HORSHAM DISTRICT COUNCIL CONSULTATION

TO:	Horsham District Council – Planning Dept
LOCATION:	Land North of Glebe Farm and Kings Barn Lane Kings Barn Lane Steyning
DESCRIPTION:	Application for Approval of Details Reserved by Conditions 8 (finished floor levels and external ground levels) and 12 (foul water sewerage disposal) to approved Outline application DC/21/2233 (265 dwellings, demolition of No. 37 Kings Barn Lane to provide new pedestrian/cycle/emergency link, provision of vehicular access from the A283 Steyning by-pass, provision of public open space, community orchard, sustainable drainage and other ancillary and enabling works)
REFERENCE:	DISC/26/0049
RECOMMENDATION:	Advice / Modification
SUMMARY OF COMMENTS & RECOMMENDATION: We cannot recommend the discharge of conditions 8 and 12. Please see below for details. There is a minor modification recommended prior to discharge of condition 8, however it is deemed minor, see below. I am satisfied Condition 12 can now be discharged but please note that as result of the modifications there are some minor changes to the landscape arrangement plan. Since the detailed planting plans/schedule has been approved with the reserved matter

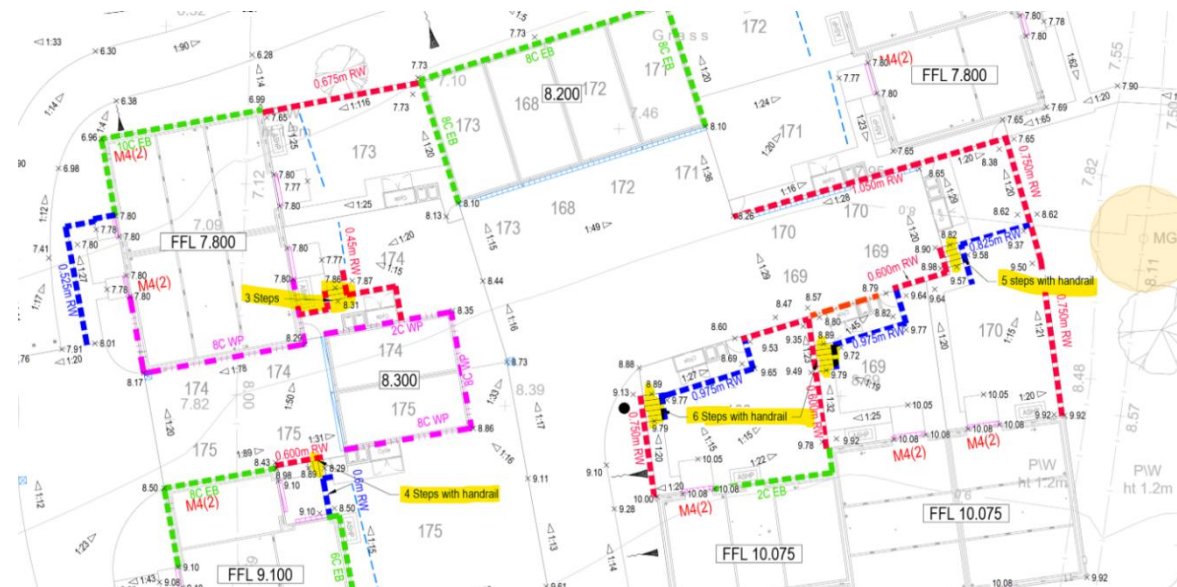
Although no major concern is raised with the proposed levels overall, we have previously highlighted under DC/25/1138 that changes to the layout proposals near one of the basins had not been amended on the levels plans to address the concern of a visitor parking in close proximity to the basin - please update layout to reflect these changes. The extract of the area as below:

The issue above has been addressed with thanks.

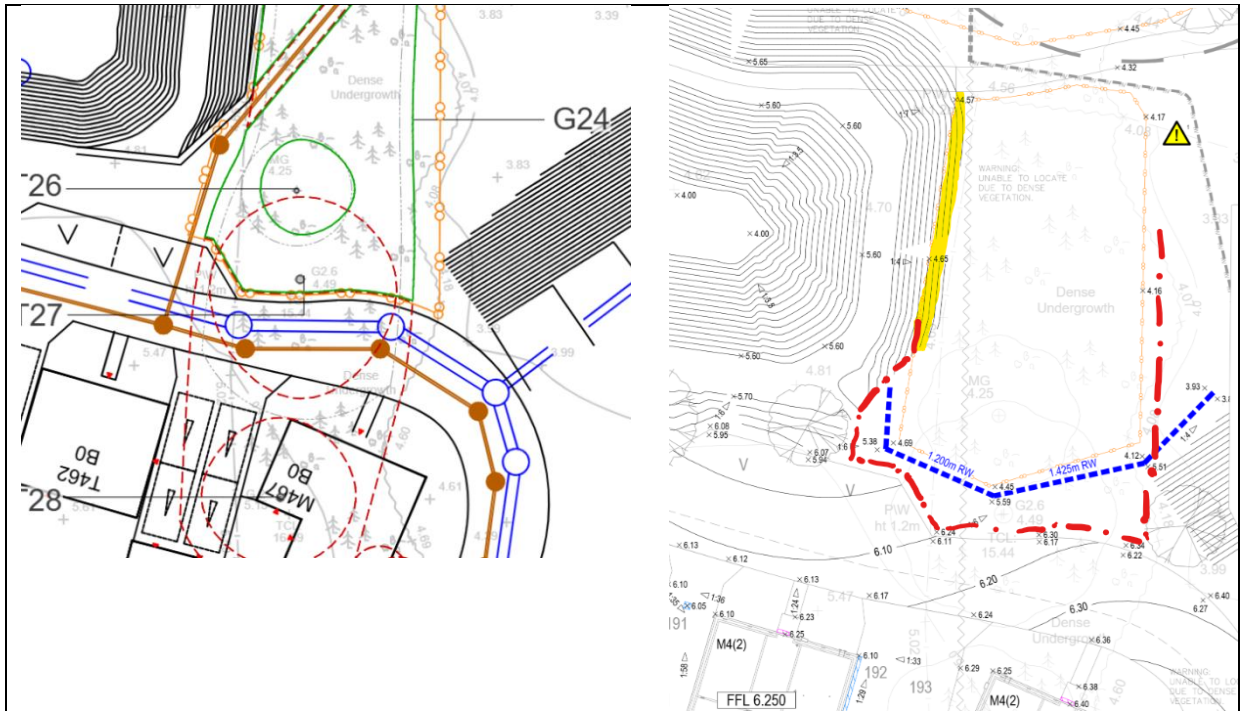
However, for awareness I wanted to flag that as result of further detailed design, there has been change to some of the proposed FFL's, resulting in some big changes to the overall proposed levels strategy including the addition of a high retaining wall in between rear gardens of plots 168 to 212 and a number of stepped accesses to individual properties, particularly within the northern part of the site. These are not an issue in itself from a landscape perspective, as most are contained within rear gardens and concealed within retaining walls, see example in the extract below:

There is nevertheless concern that the amount of G24 being removed is significantly more than that indicated within the approved Tree Retention Plan, as result of the suds basin and the retaining wall, noting that T27 has already been lost between outline to reserved matters. While this is far from ideal, I can see this is the result of not only the changes to the level strategy but also the easement for the proposed water pipes. The second extract shows (dashed red line) roughly the extent of additional existing vegetation removal. I am raising for your awareness and in case there are any other consequences of this for other ecology commitments.

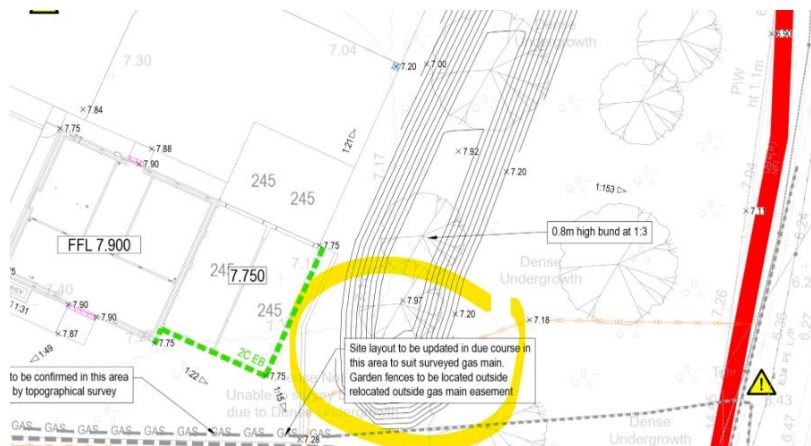
There is nevertheless concern that the amount of G24 being removed is significantly more than that indicated within the approved Tree Retention Plan, as result of the suds basin and the retaining wall, noting that T27 has already been lost between outline to reserved matters. While this is far from ideal, I can see this is the result of not only the changes to the level strategy but also the easement for the proposed water pipes. The second extract shows (dashed red line) roughly the extent of additional existing vegetation removal. I am raising for your awareness and in case there are any other consequences of this for other ecology commitments.

The removal of the bund from encroaching into tree protection area is recommended however:

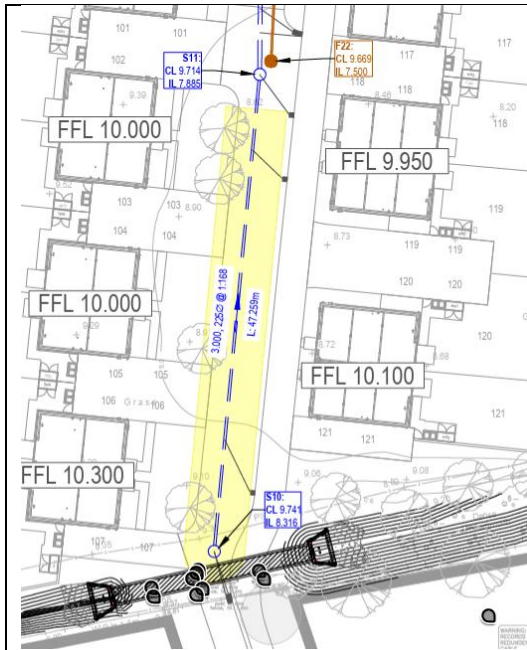
New proposed trees have been identified within the 3m easement zone in various locations. While in some cases this may be easily adjusted as these are within the open space, other areas such as street trees in the example below (not exhaustive) are of concern.

Please adjust surface water pipes so that it's demonstrated the tree strategy can be delivered as approved and service providers are satisfied with the proposed relationship. Note root barriers will also be required and locations must indicated in the plans.

CLOSED.
